Parramatta Light Rail
Level 10, 130 George Street,
Parramatta NSW 2150

12th December 2022

Re: Parramatta Light Rail Stage 2 EIS

Figure 3: Cross section of Hill Road in Wentworth Point showing existing and proposed allocation of road space (Source: TfNSW / ASPECT Studios)

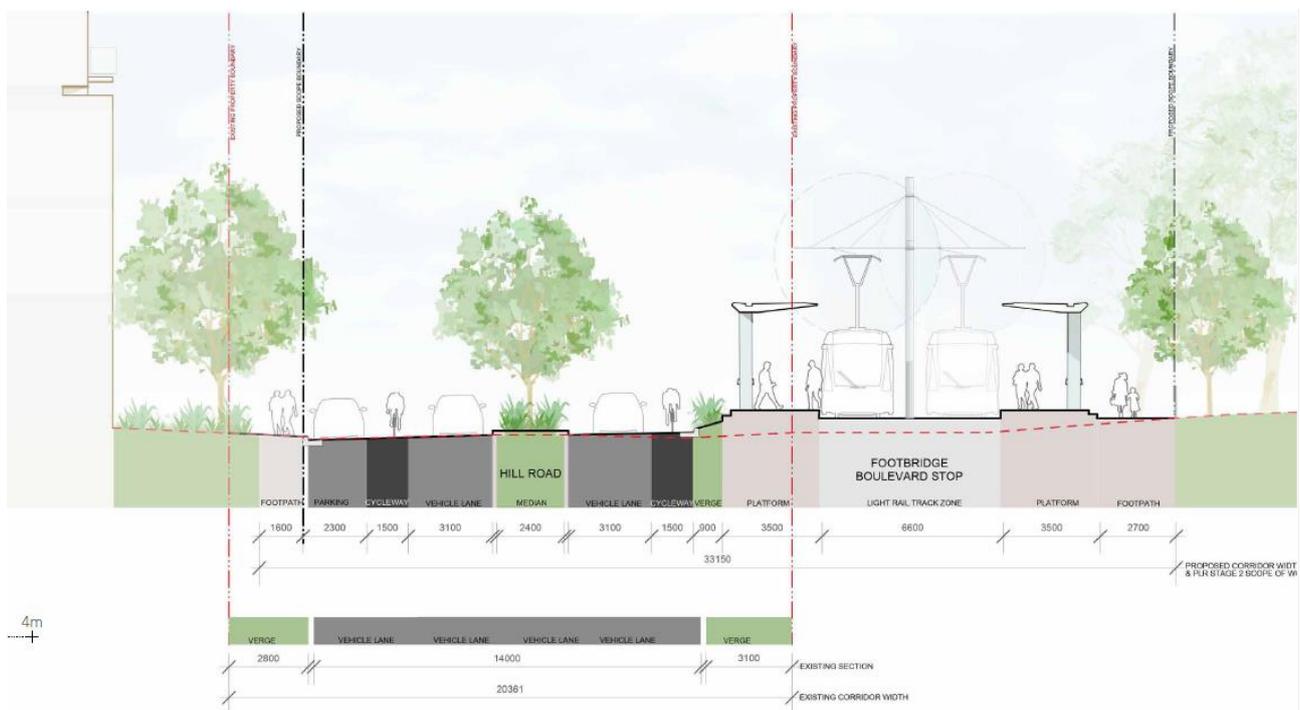
Elements of the Hill Road cross section are surprising and not in the spirit of the rest of the PLR2 proposal. For example, on-road mixed traffic cycle lanes are shown (Figure 3). Bike riders will be placed in the 'door zone' of parked vehicles.

The Bicycle NSW *Build it for Everyone* policy pillar^{vii} sets a standard that bicycle infrastructure should be fit for eight-year-old children or elders to ride on. Door zone bike lanes, bike stencils on the road and dangerous intersections will continue to deter the 48%^{viii} of people who are 'interested but concerned', from making the switch to bike riding.

Figure 5: Cross section of Hill Road near Holker Street in Wentworth Point showing existing and proposed allocation of space (Source: TfNSW / ASPECT Studios)

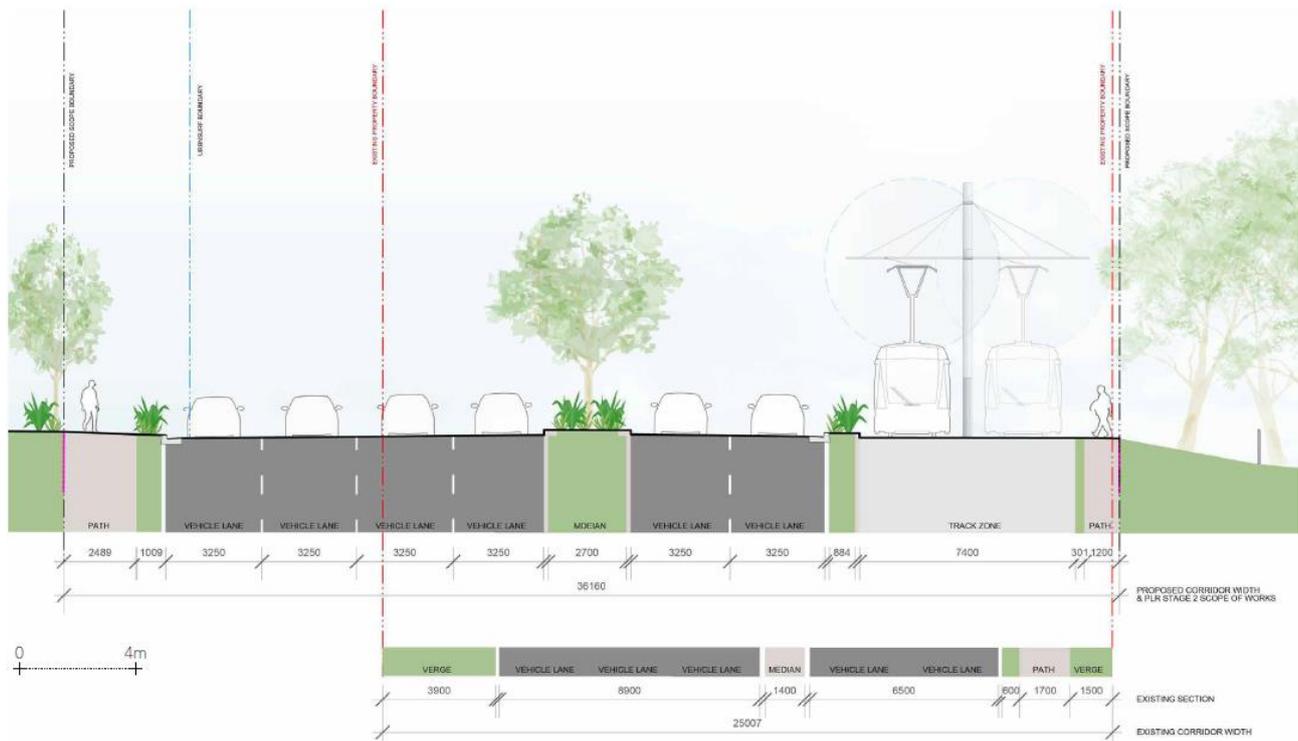
Another Hill Road cross section (Figure 5) shows a substandard 2.5m shared path alongside 6 vehicle lanes. The existing road has 5 lanes. The project team states that vehicle capacity cannot be reduced on Hill Road^x as it is the only access to Wentworth Point. However, there can be no reason to create *an extra lane* and prioritise car traffic over the best outcomes for walking and cycling.

Figure 7: Map showing the two Camellia to Rydalmere alignments (Source: TfNSW)

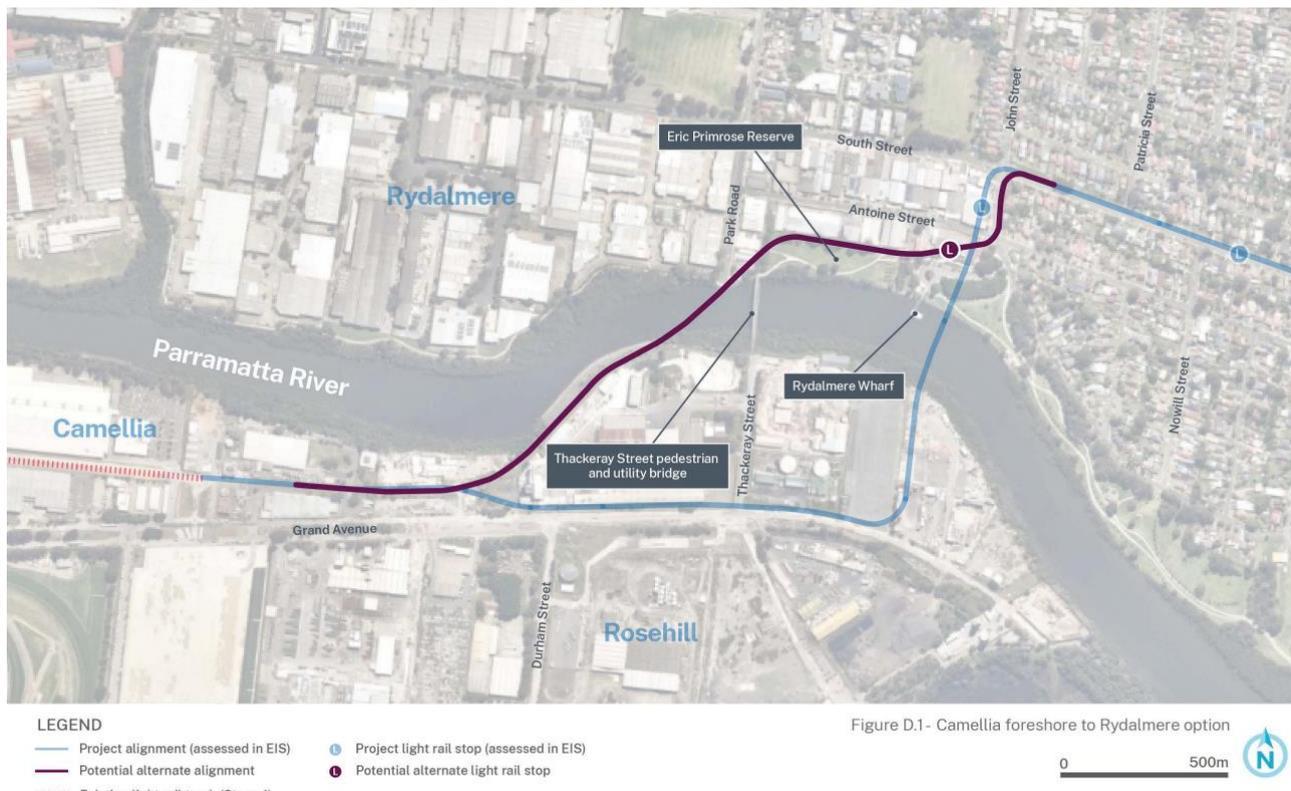
Appendix D of the EIS sets out an alternative route for connecting Rydalmere and Camellia, taking the light rail and the ATL along the foreshore of the Parramatta River (Figure 7). Our initial response is that the **Grand Avenue alignment is preferred**. The foreshore is a sensitive environment with established mangrove forests which would be permanently altered by transport infrastructure running very close to the river's edge. We understand that it will be difficult to acquire sufficient land along the foreshore to locate the light rail tracks well away from the water. However, we definitely support the addition of a standalone shared path along the foreshore. This would require a much narrower strip of land.
